**Re: Hydrogeological Reevaluation Report
Goldfinch Lane Crossing (S2-0069)
Permit No. E11-352
Jackson Township, Cambria County**

In compliance with the Corrected Stipulated Order dated August 10, 2017 a Reevaluation Report on the above-referenced horizontal directional drill (“HDD”) was submitted to the Department on January 26, 2018. In a letter dated February 16, 2018, the Department requested further information. Please accept this letter as a response. Your requests are bolded below followed by the response.

Attachment 2
Water Supply Illustration

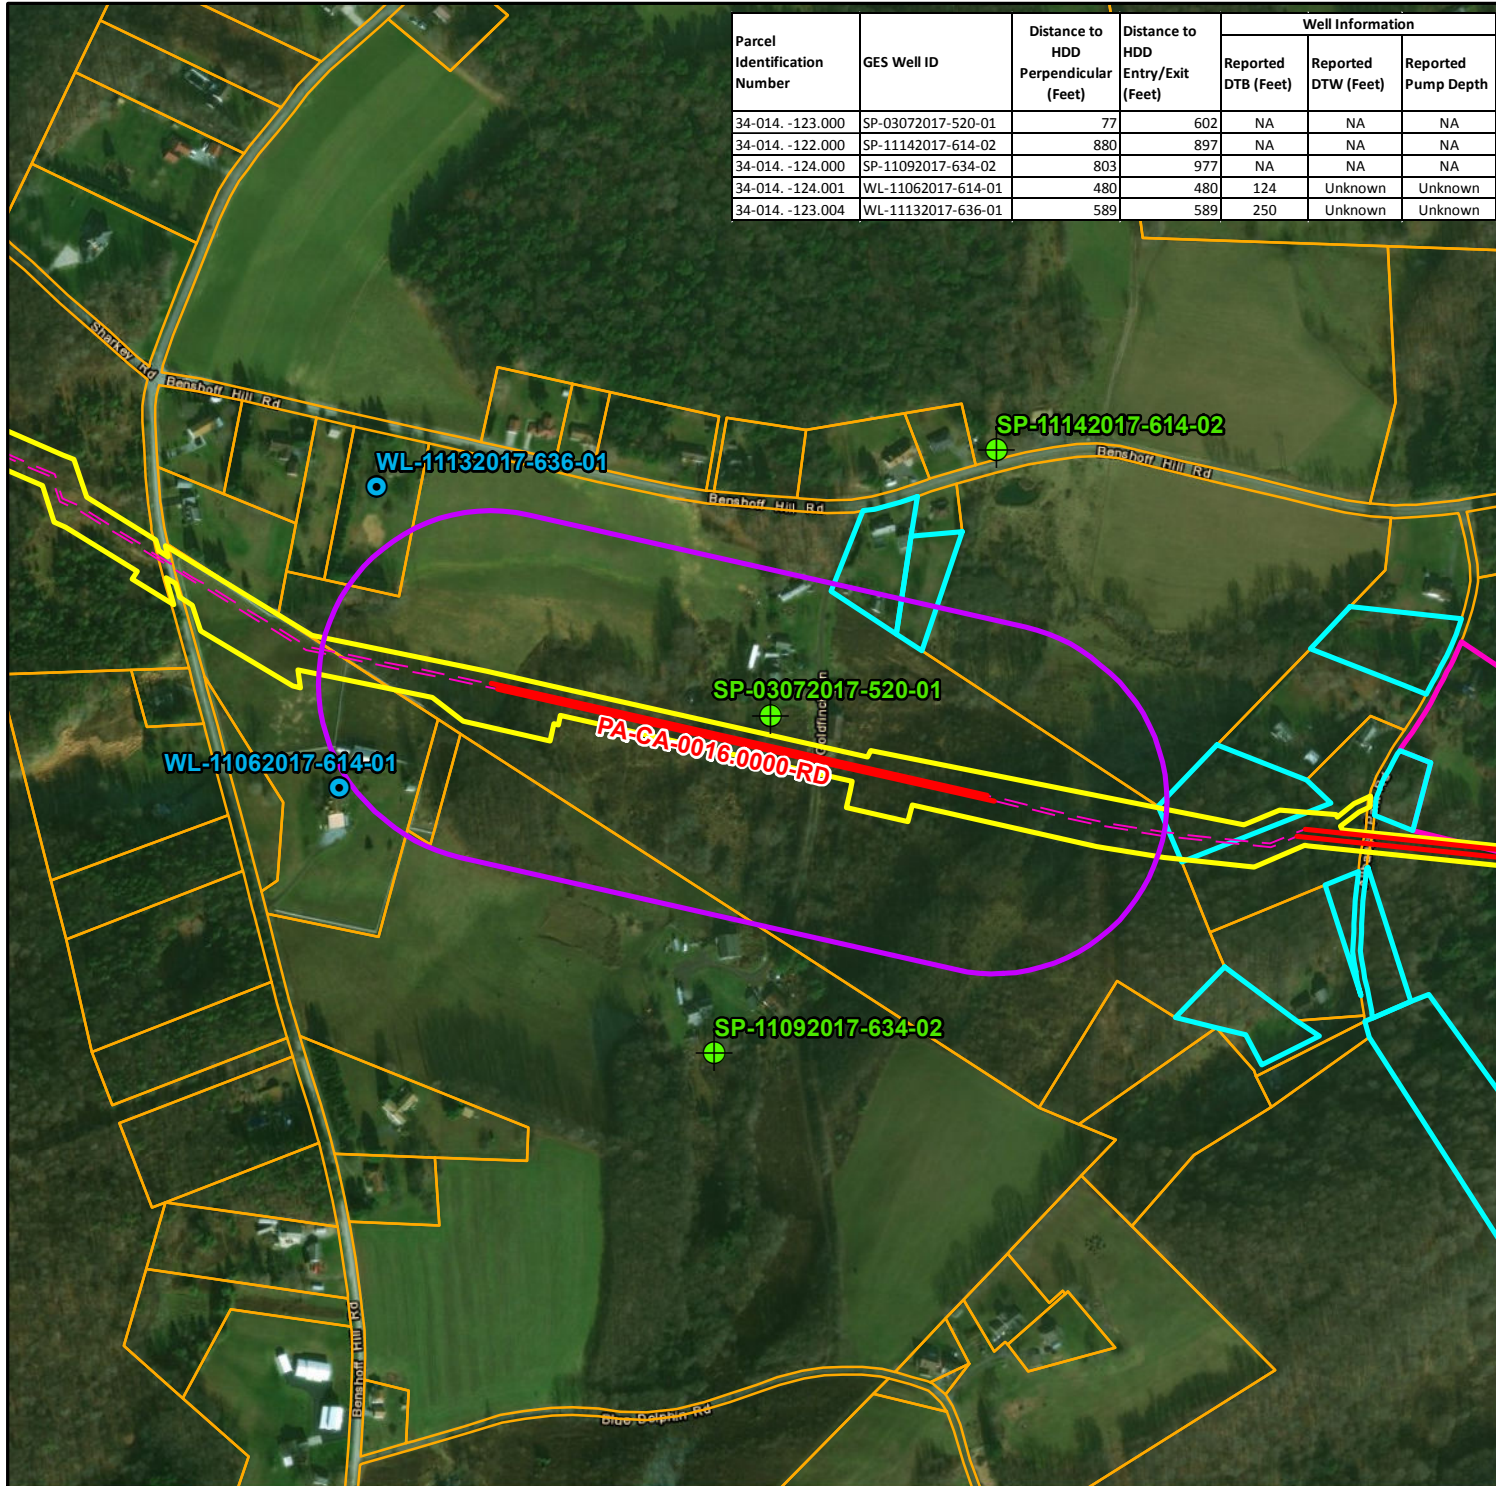
- 3. Please provide DEP with information related to the Goldfinch Lane Crossing's potential effect on well production zones and water supplies, including an analysis of private water supply well production zones and how the proposed HDD activities interact with them. Please note that listing the depths of wells and pumps is insufficient.**

As shown on the updated Water Supply illustration provided as Attachment 2 there is one (1) private water supply, a spring, located within 450 ft of the HDD profile.

Professionally licensed geologists in the state of PA contracted by SPLP believe the intended subject matter of the question listed in Item 3 is the source of water feeding the spring (sole identified water supply). The spring is located due north of the west to east trending HDD alignment, at the bottom of a slope rising west and southwest from the location of the spring. GES has sampled this spring twice; once in March 2017 and again on March 28, 2017. The observed conditions of the spring were similar between events. A black PVC intake pipe with

The alignments for HDD S2-0069 and HDD S2-0069-16 run south and within 100 feet of the spring house. The planned profiles for the pipelines are approximately 45 feet and 65 feet (20-inch and 16-inch pipelines, respectively) below the elevation of the spring house. Given the local hydrogeologic setting SPLP cannot completely rule out the possibility that the quantity and quality of water emitting from the spring may be temporarily affected by the drill. Even though this water source is considered marginal and is not used for drinking water purposes, the land owner has been offered a temporary replacement supply during HDD construction, and thereafter, until it can be demonstrated that the quantity and quality of the water supply are similar to preconstruction conditions.
